AGENDA FOR REGULAR MEETING VILLAGE OF TINLEY PARK PLAN COMMISSION

August 02 2018 – 7:00 P.M. Council Chambers Village Hall – 16250 S. Oak Park Avenue

PLAN COMMISSION STAFF REPORT

ARCHITECTURE

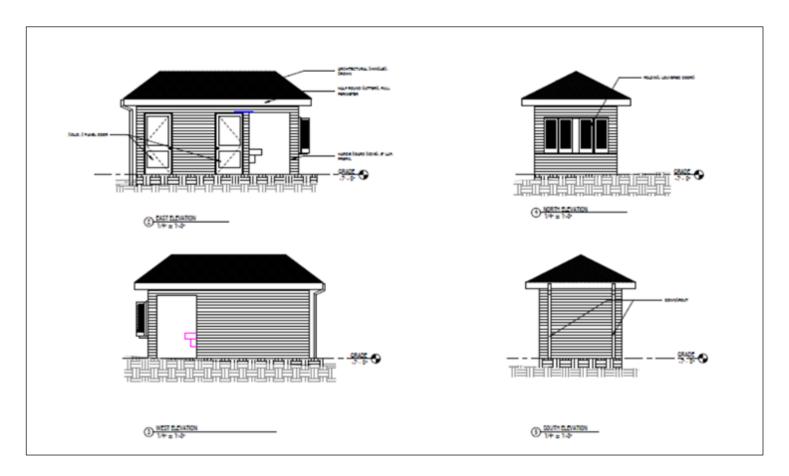
The proposed accessory structure will be comprised of a prefinished 5" Lap Hardie Board Siding with brown architectural shingles. This complies with the Legacy Code Section 3.B.7.a which requires a minimum of 75% of all facades to be comprised of Brick, Stone and Fiber Cement Siding and the roof to be Cedar, Slate or Asphalt Shingles. The north elevation facing the outdoor patio will have folding louvered doors that open out to a counter that can be used by staff. The solid 2 panel doors on the bathroom will face east towards the main outdoor dining area an Oak Park Avenue. Staff has requested color elevations to ensure that the accessory structure will complement and blend in with the primary building.

Open Item #3: Provide a color rendering of the accessory structure. The accessory structure shall compliment/match the principle structure. A color rendering was provided for review at the meeting and it was suggested that the structure incorporate accent colors similar to the principal building instead of the structure being one color throughout. A revised colored elevation has been submitted but it does not show the shutters being paitned. Prior to Village Board approval, the petitioner will need to submit the final color renderings.

SITE PLAN

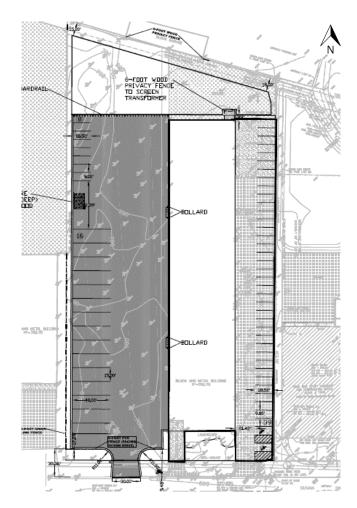
A recommended condition has been added to the motion requiring removal of the parking lot and installation of grass be placed on the Site Plan and Variation approvals. This also exists in the deed restriction, but the conditions will make it more likely that this requirement is not missed in the future. A final draft of the deed restriction was reviewed by the Village attorney and is attached to the packet. A recommended condition requiring that the deed restriction be recorded prior to any building permit approvals has been added to the motion.

The Petitioner is proposing that the site plan improvements (parking lot, landscaping and stormwater detention) be approved to work in conjunction with the adjacent 23,500 square foot warehouse building. The new parking lot would be located west of the existing building. It would be used primarily for the storage of the businesses moving trucks (16 truck parking spaces) but would also have some additional employee parking (8 new employee spaces). Overhead doors would be added to the west façade to allow trucks to access the building from the new parking lot. The new parking lot would be partially fenced for security purposes. PVC will be used for aesthetic purposes on the south side Duvan Drive frontage. Chain link fencing would be used on the west side and wood fencing is proposed on the north side. The perimeter of the property's west, east and north sides will also be landscaped. A Stormwater

detention and volume control area in compliance with Metropolitan Water Reclamation District (MWRD) standards is being installed to the north end of the property.

There is a clearance ranging from seven to nine feet (7'-9') going through the site and right-of-way are that would be unimpeded by trees (there is some smaller shrub and ground cover landscaping) and could be used for placement of sidewalk in the future. Due to the lack of engineering review comments, a recommended condition has been added requiring that the approval is subject to addressing all engineering comments and obtaining an MWRD permit.

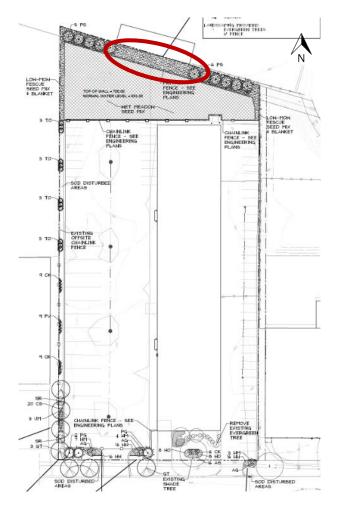
The Petitioner's proposed landscape plan requires a number of waivers from the Landscape Code and bufferyard requirements (complete analysis of code requirements attached in Table A). Most notably the parking lot is required to have interior landscaping with trees installed. The parking lot is unique because it will not be a standard parking lot accessed by employees or the public. It will be primarily used by the business's full-sized trucks that will need to maneuver through it. Due to this unique use of the parking lot and Petitioner's request to waive interior landscaping, staff has recommended that the perimeter bufferyard screening be as lush and thick as possible to compensate for the loss elsewhere and meet the intent of the code requirements. A heavy use of shade/canopy trees is recommended as the best visual buffer and also due to the many aesthetic and environmental benefits they bring. Shrubs and ground level landscaping can be used on a limited basis around most of the perimeter due to difficulties maintaining them on a heavily traveled industrial site. The front (south side) of the site will be heavily landscaped including trees and shrubs to create some curb appeal and is in full compliance with the bufferyard requirement.

While some canopy and buffer trees have been added, there are some additional areas that canopy and shade trees can be placed to meet the bufferyard requirements and help offset the loss of interior parking lot landscaping and trees.

The petitioner agreed to add additional trees to the rear/north property line abutting the residential property. It was recommended that the proposed trees could be spaced further apart based on their landscaper's recommendation with the result should be a consistent tree line across the property line that reduces visibility to the industrial property.

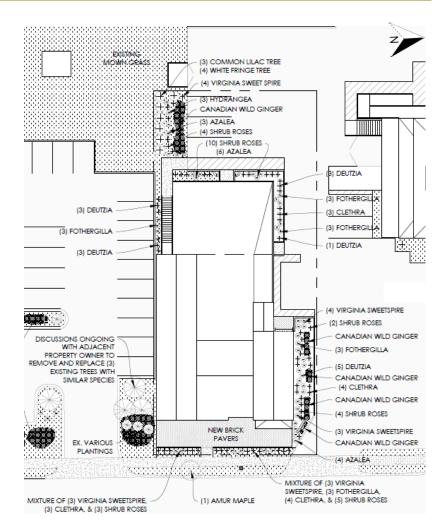
The Legacy Code requires dedication of a twenty-five foot (25') wide alley at the rear of the property. No alley is planned to be completed with this project or in the near future. However, the dedication will allow it to be built and connect to Hickory Street in the future if necessary This alley dedication will be completed similar to other redevelopments in the Legacy District. The dedicated alley area will remain striped with on-site parking for the time being. The plat will be prepared by the Applicant's engineer and will be submitted for review and approval at the public hearing.

Open Item #2: Submit the plat of easement for a twenty-five (25') wide alley on the west side of the property.

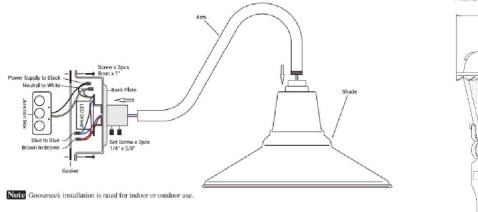
Staff's only concern with the proposed signage involves the front façade wall sign that is being placed over a façade architectural detail. Typically covering up architectural details with signage is not permitted by the code and there is a more clearly identifiable sign band area. Staff recommends considering making the wall sign smaller, utilizing a projecting sign, moving the sign to a different location on the facade or flipping the gooseneck lights and wall sign locations as alternatives to the Petitioner's proposed sign location.

Open Item #5: The front façade wall sign location is located over the architectural trim of the building. Staff recommends considering making the sign smaller, moving the sign to a different location or flipping the light and wall sign locations on the addition as alternatives to the Petitioner's proposed location.
